ADDENDUM NO. 2

Life Sciences Collaboration
 1910 N. Antelope Valley
 Parkway
 Lincoln, Nebraska
 TCEP No.: 716-002-12
 Davis Design.: 12-0077
 BVH No.: L12018.unl
 November 27, 2013

Second Floor Plumbing
Plan - Area B

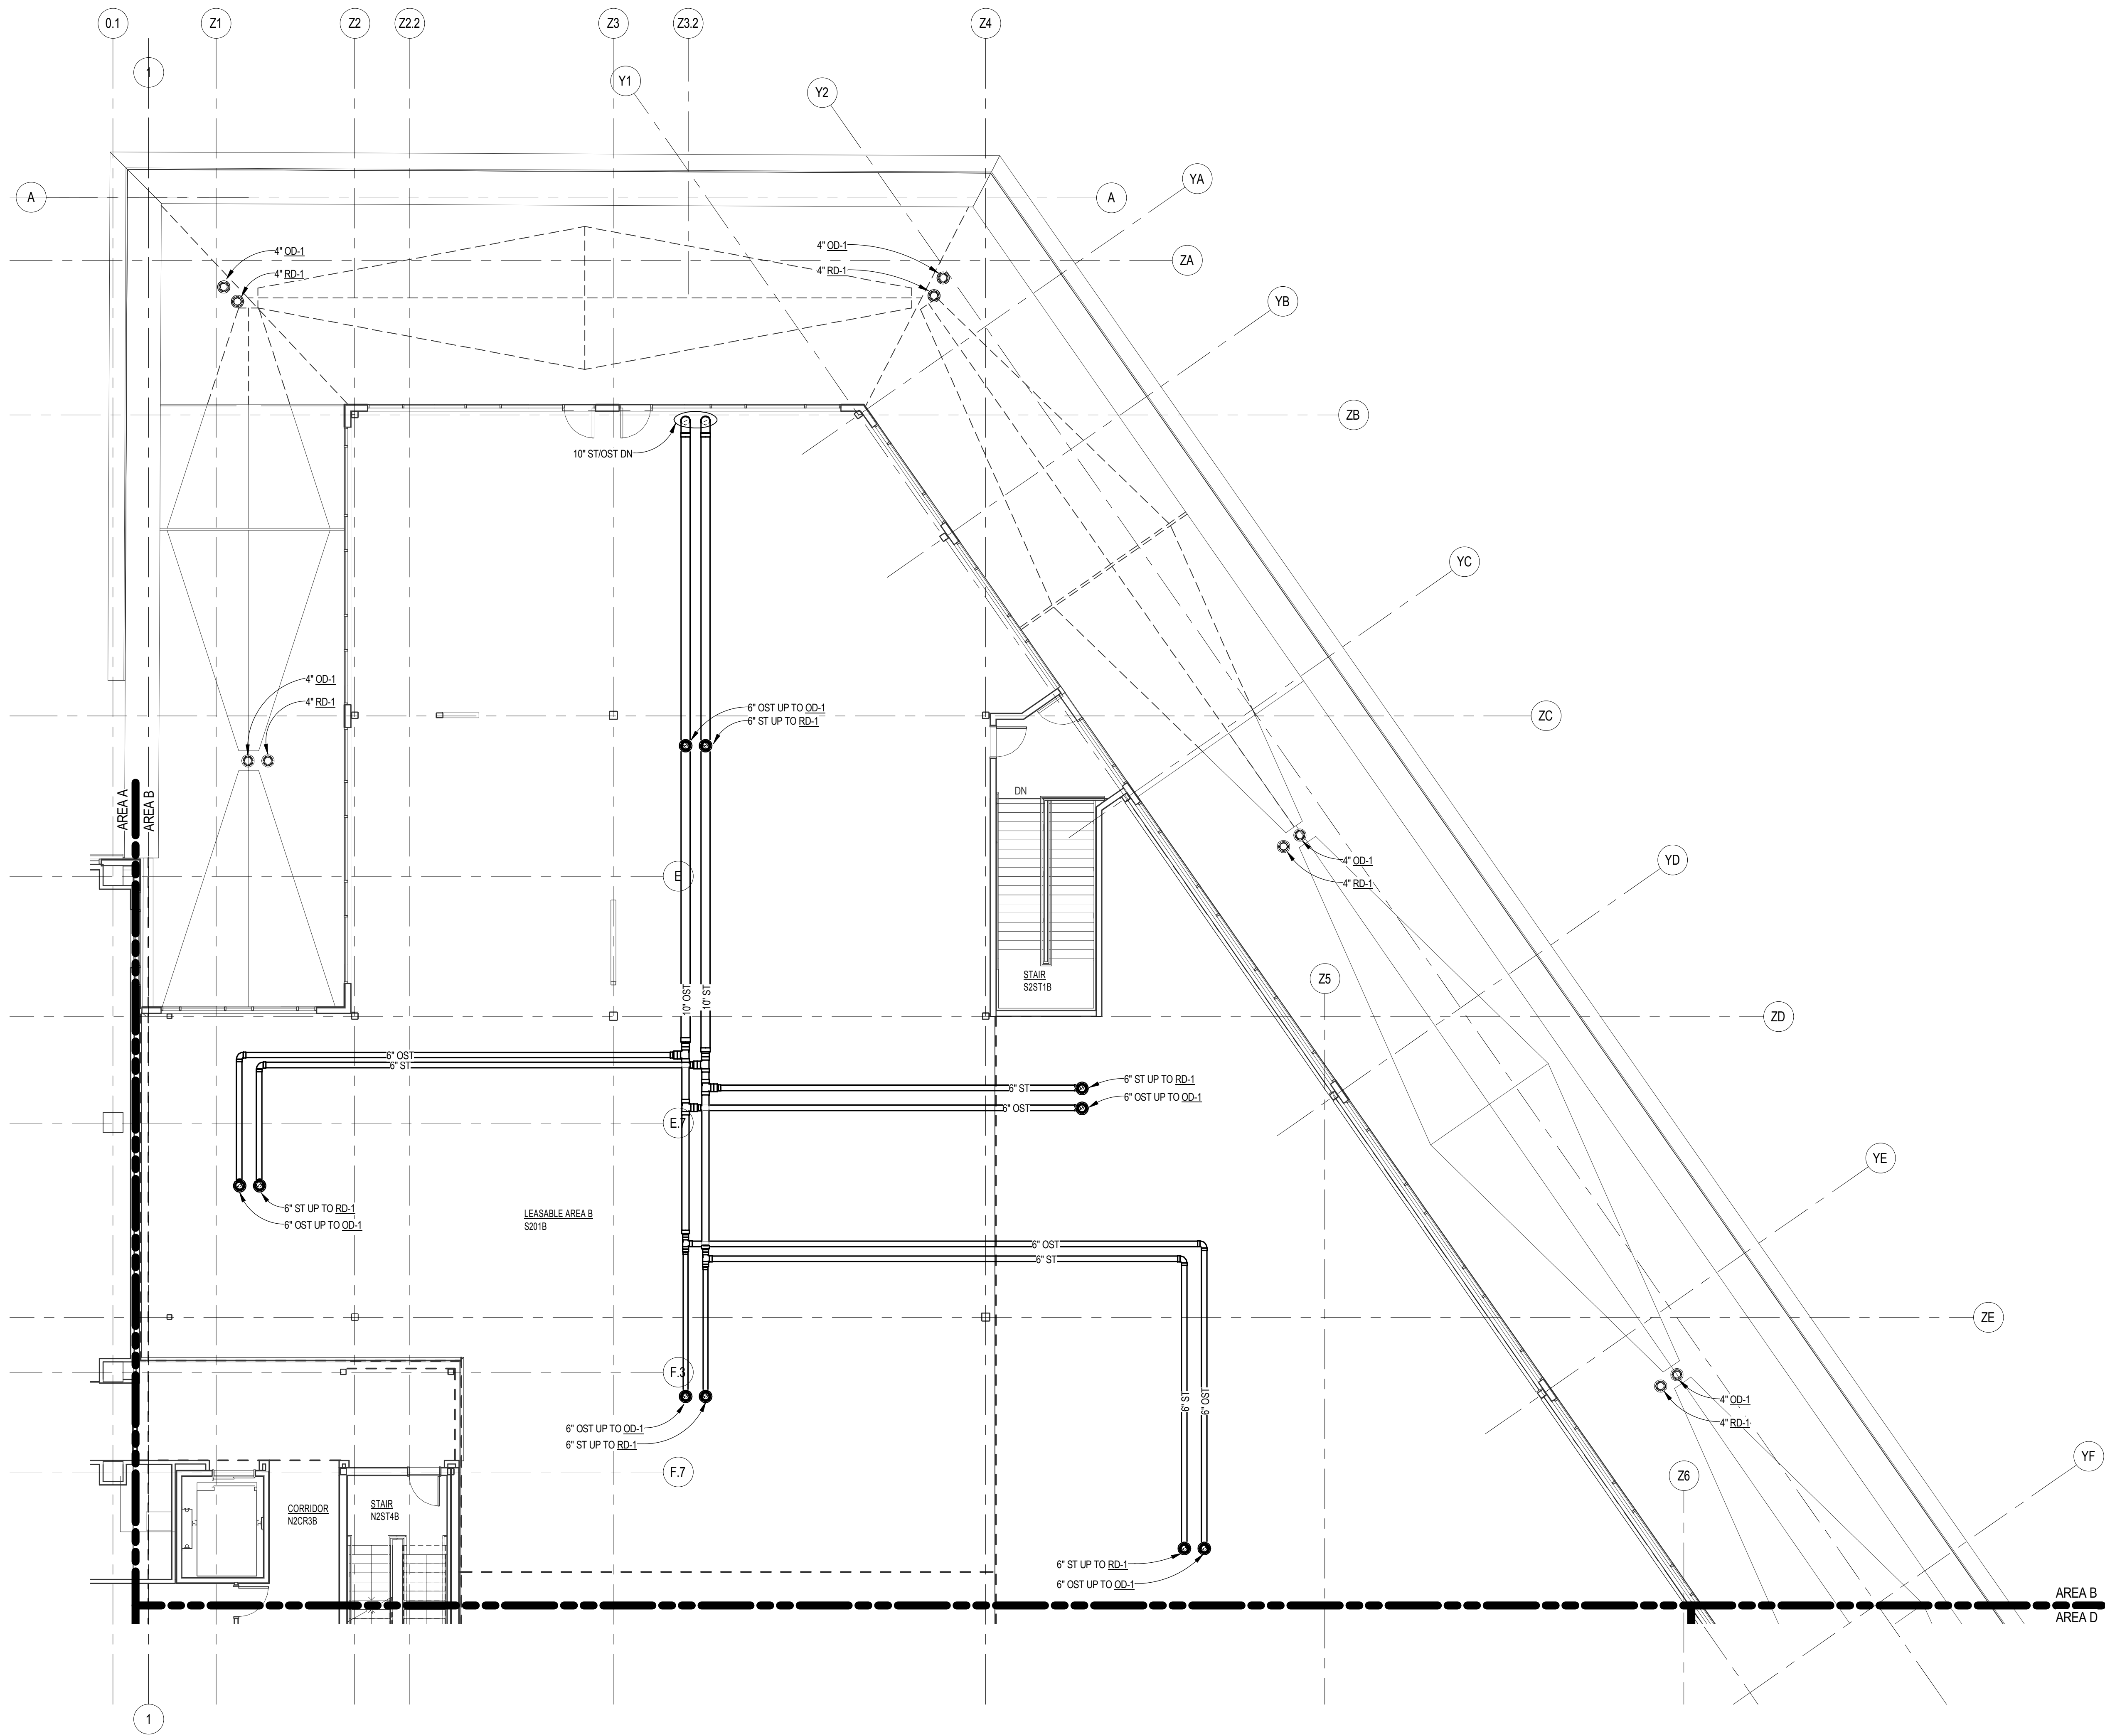
Item 2-63: P1.10 – Second Floor Plumbing Plan – Area B

See reissued sheet for revised roof drain and storm piping sizing and routing.

Second Floor Plumbing
Plan - Area C

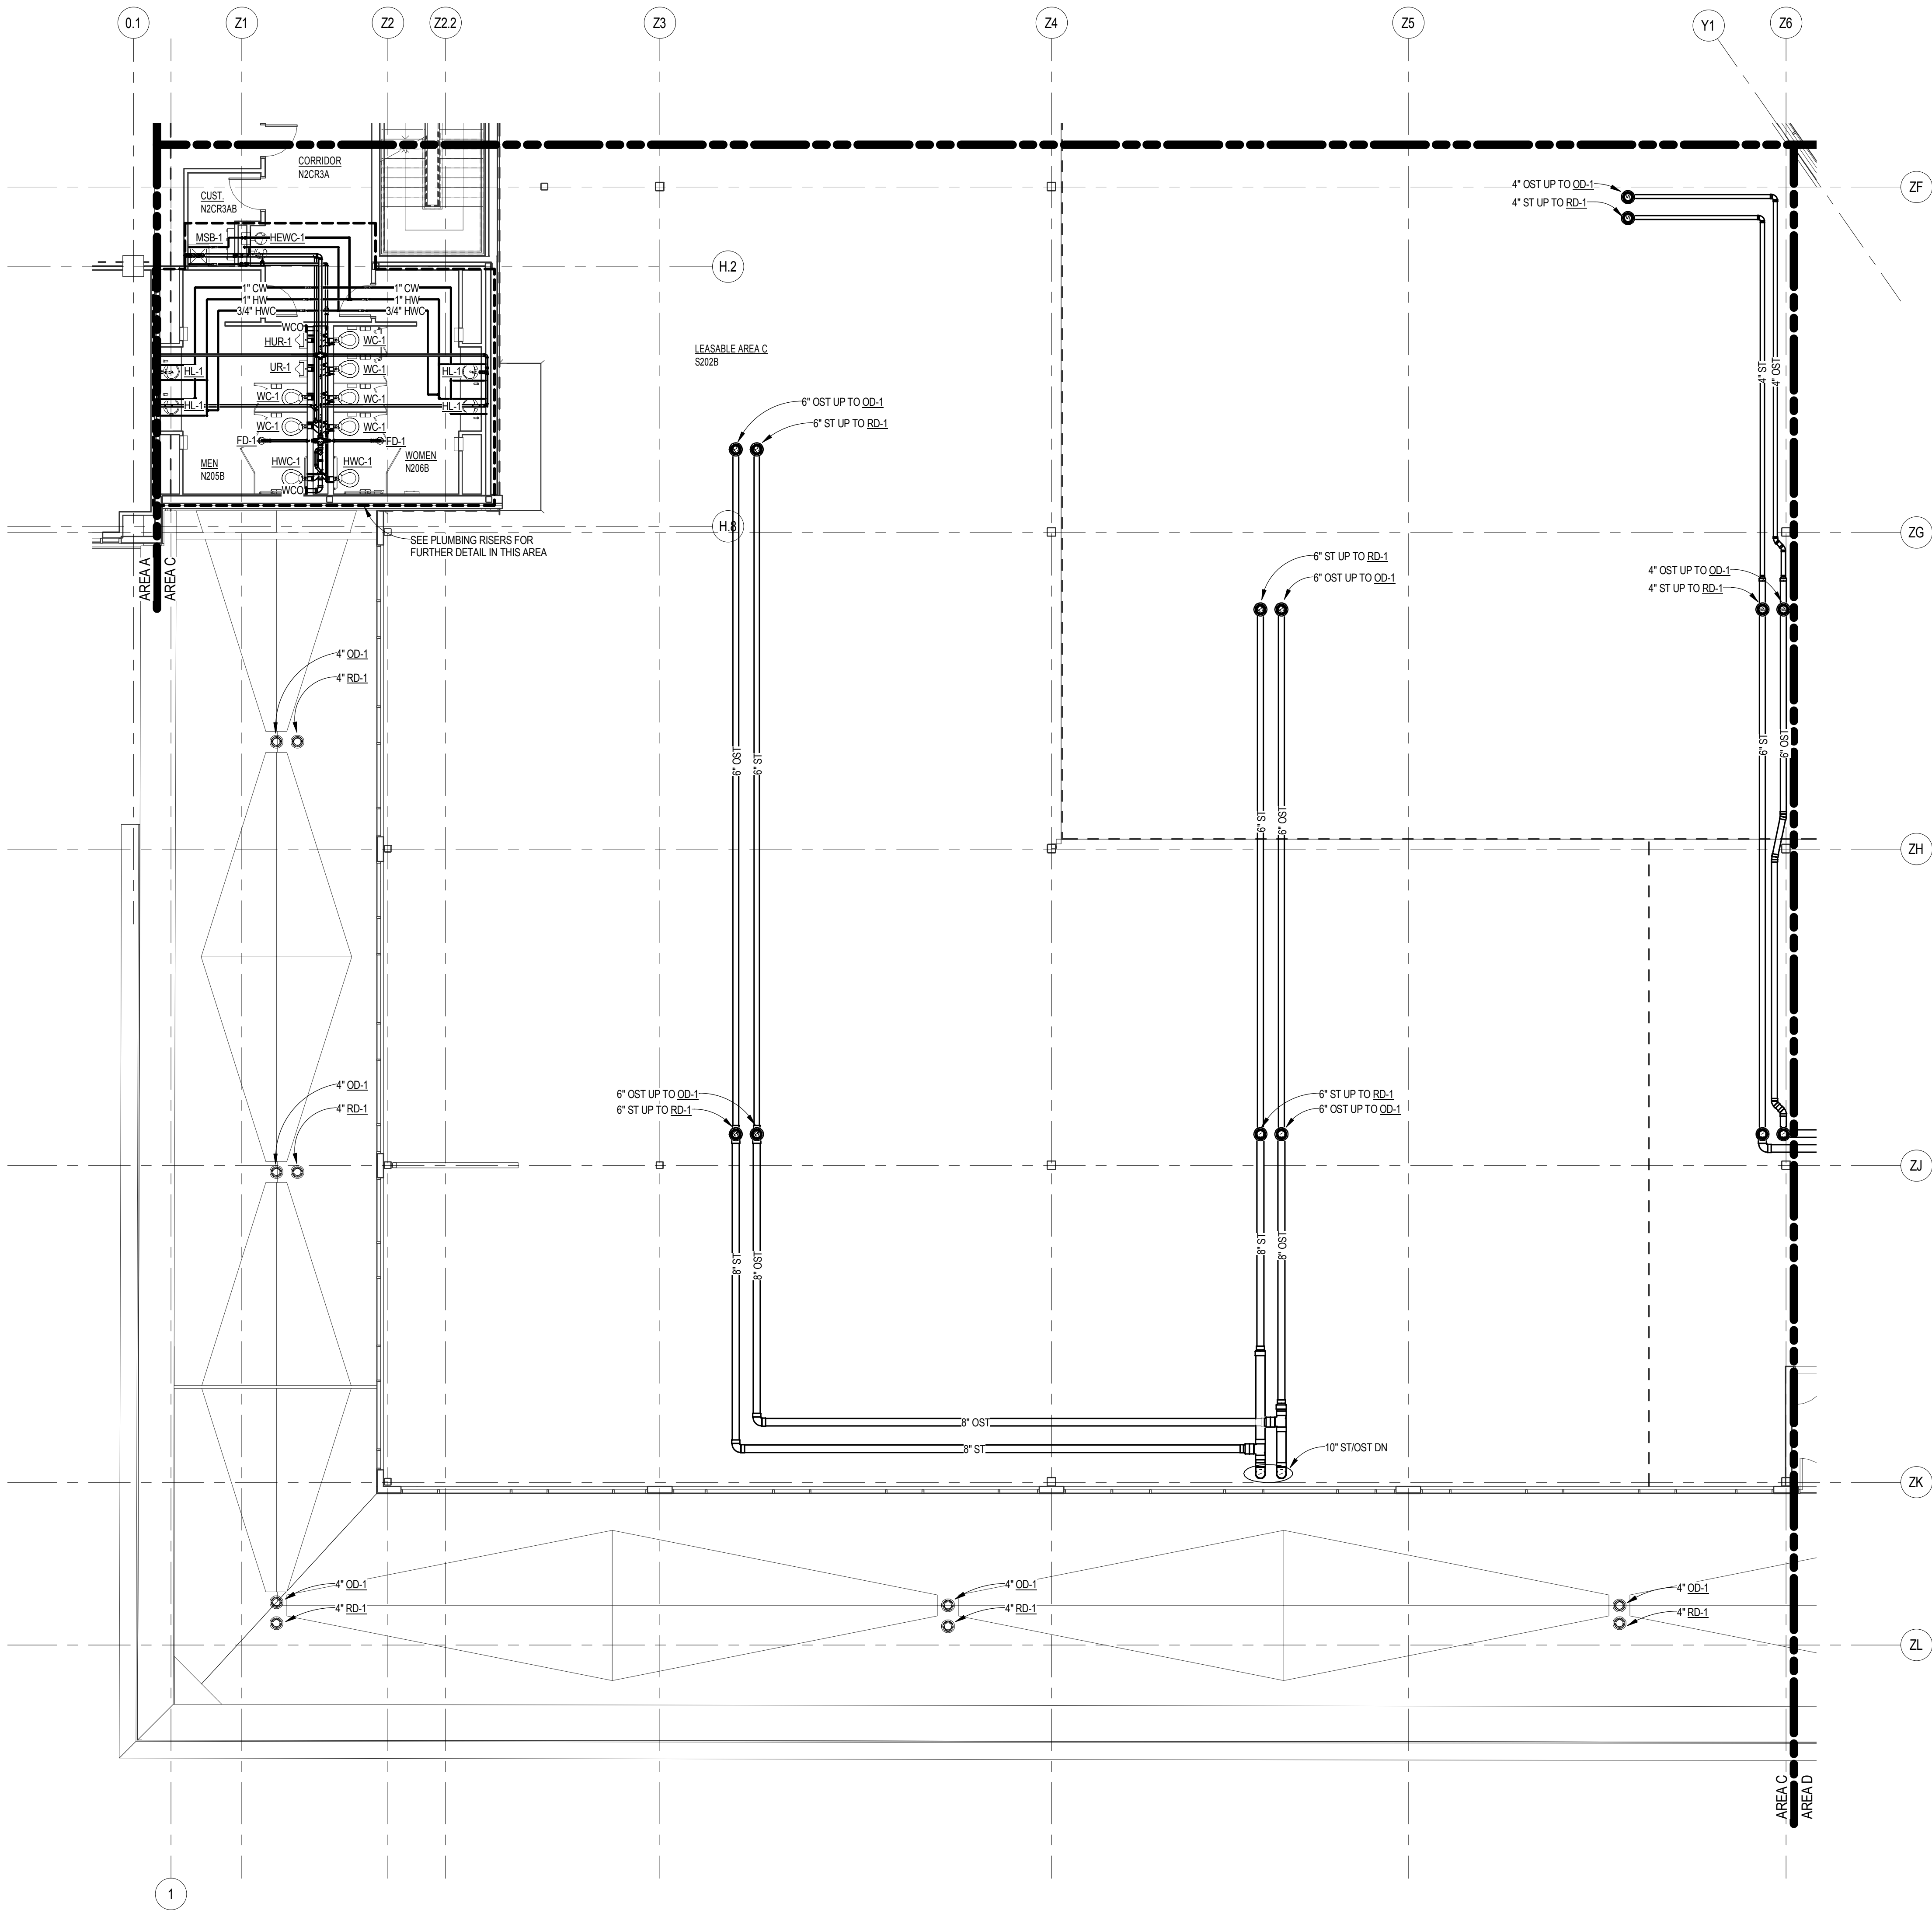
Item 2-64: P1.11 – Second Floor Plumbing Plan – Area C

See reissued sheet for revised roof drain and storm piping sizing and routing.

Second Floor Plumbing
Plan - Area D

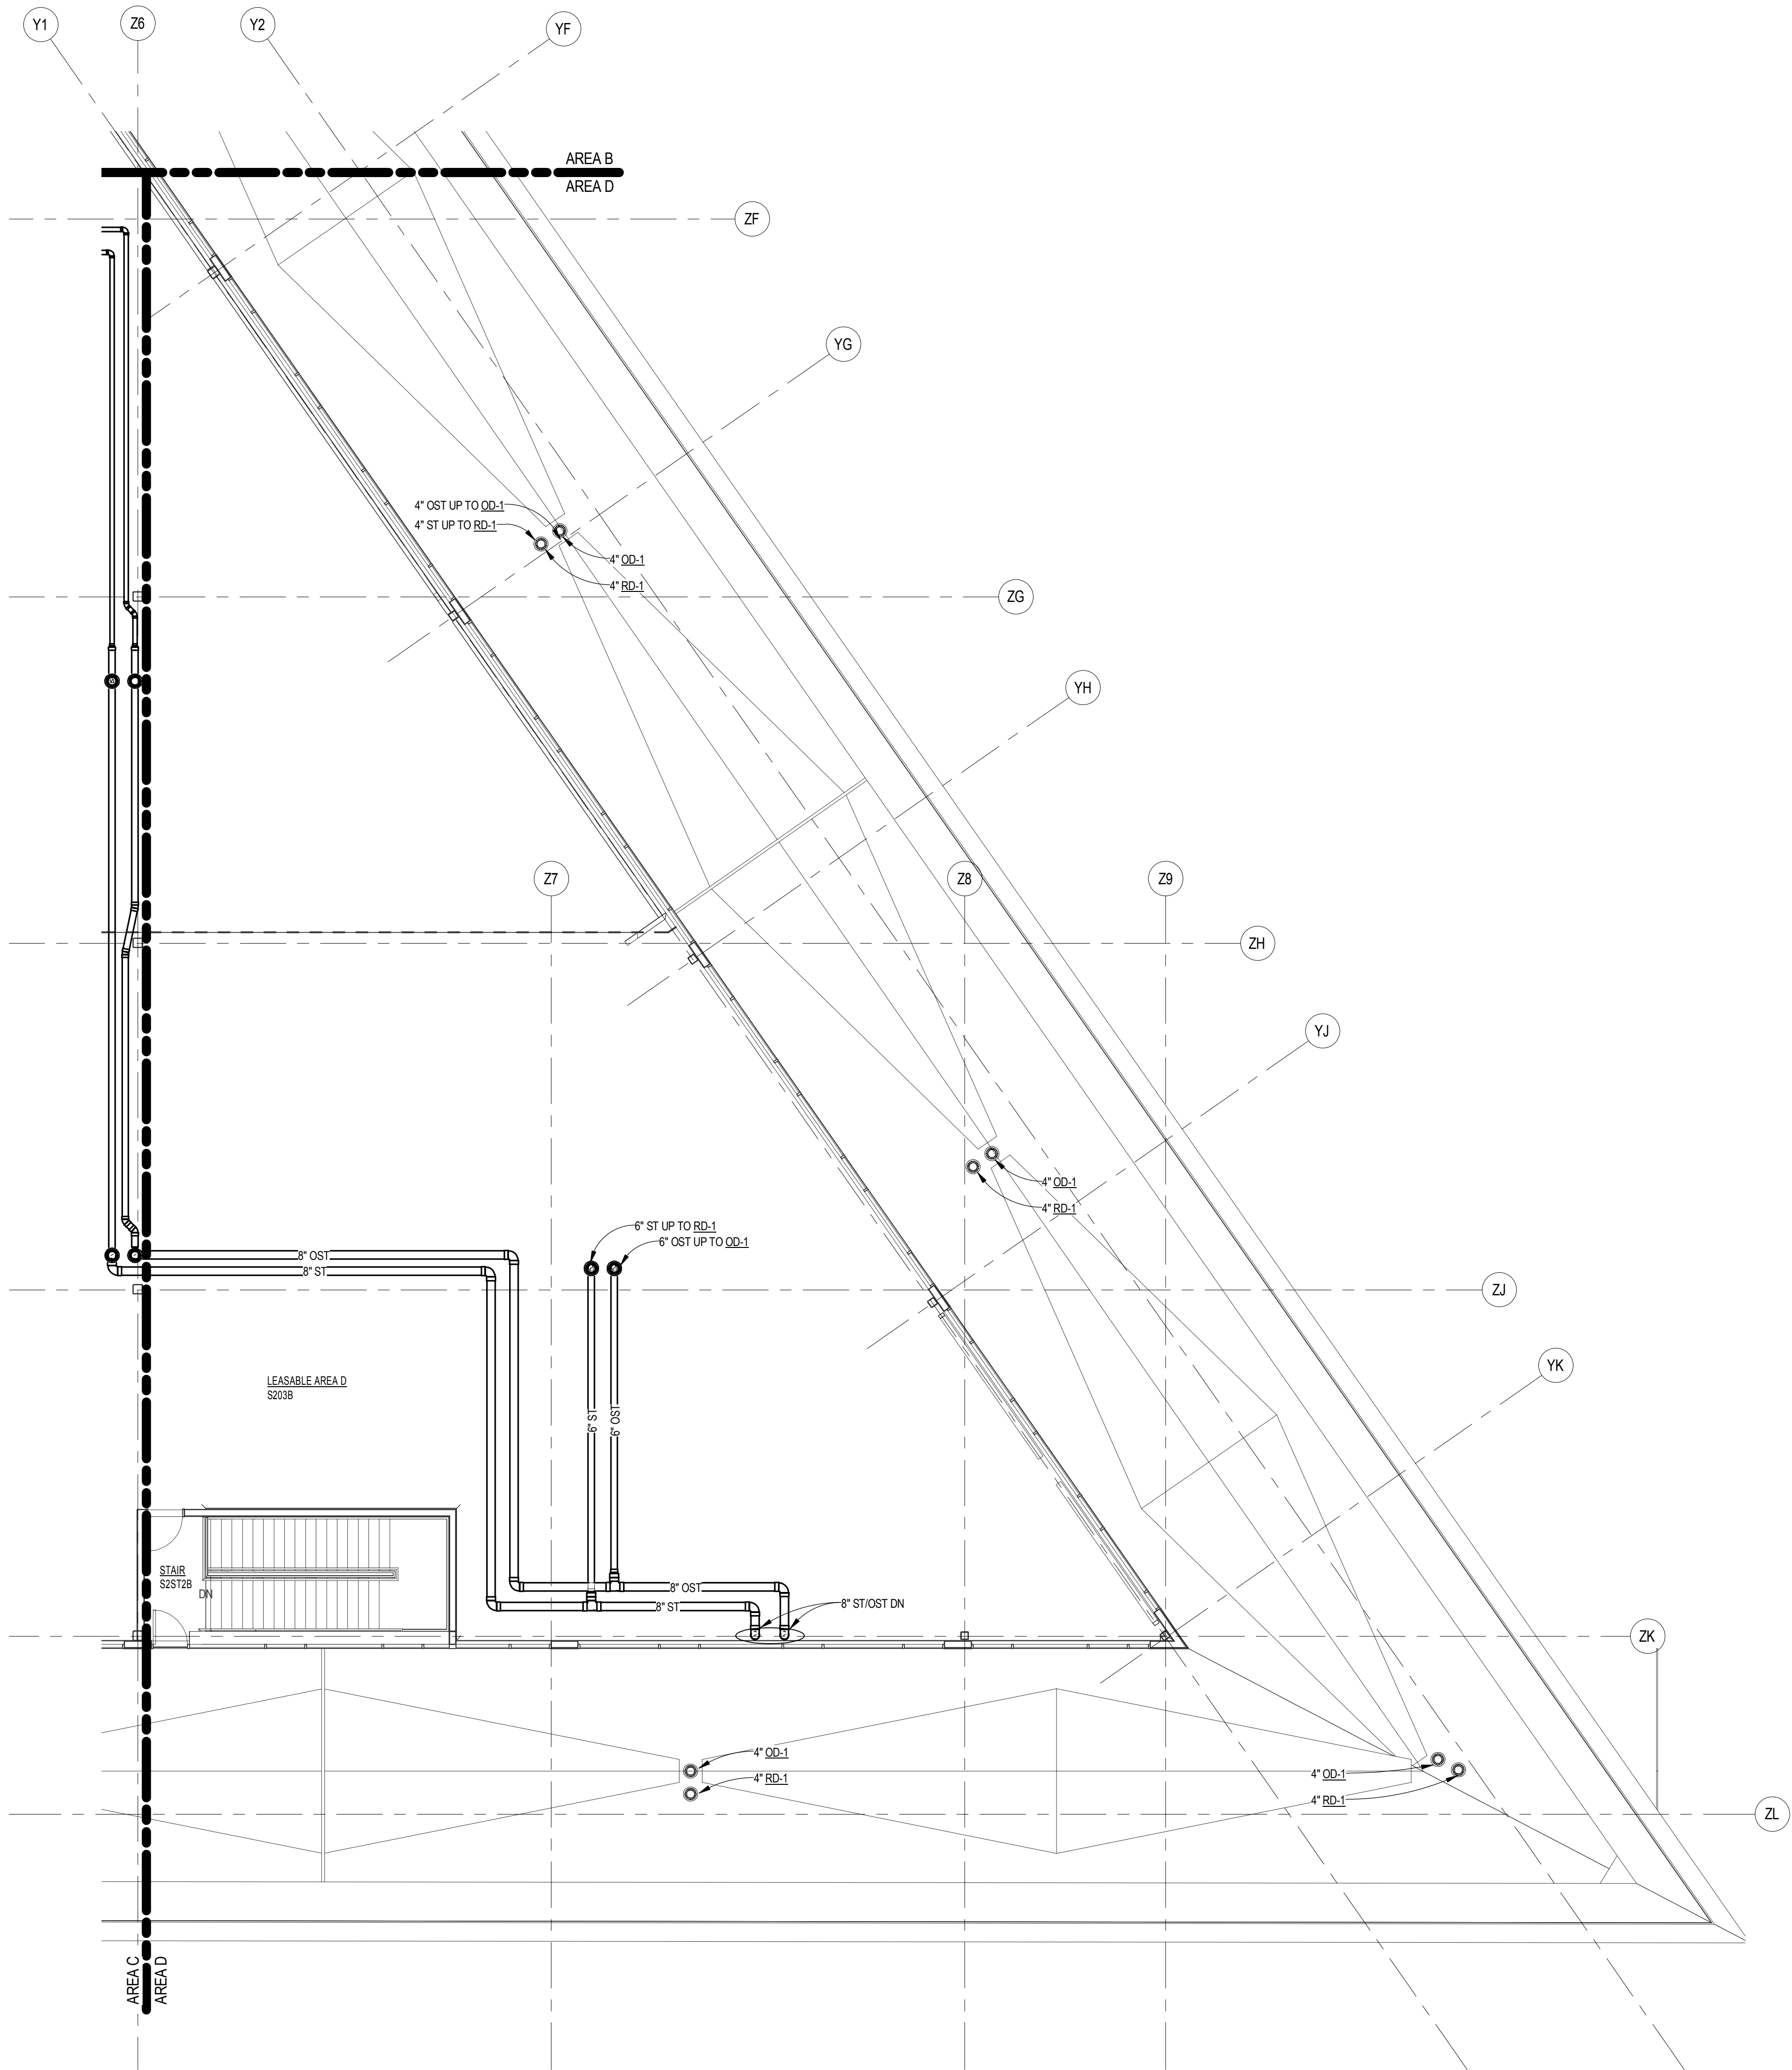
Item 2-65: P1.12 – Second Floor Plumbing Plan – Area D

See reissued sheet for revised roof drain and storm piping sizing and routing.
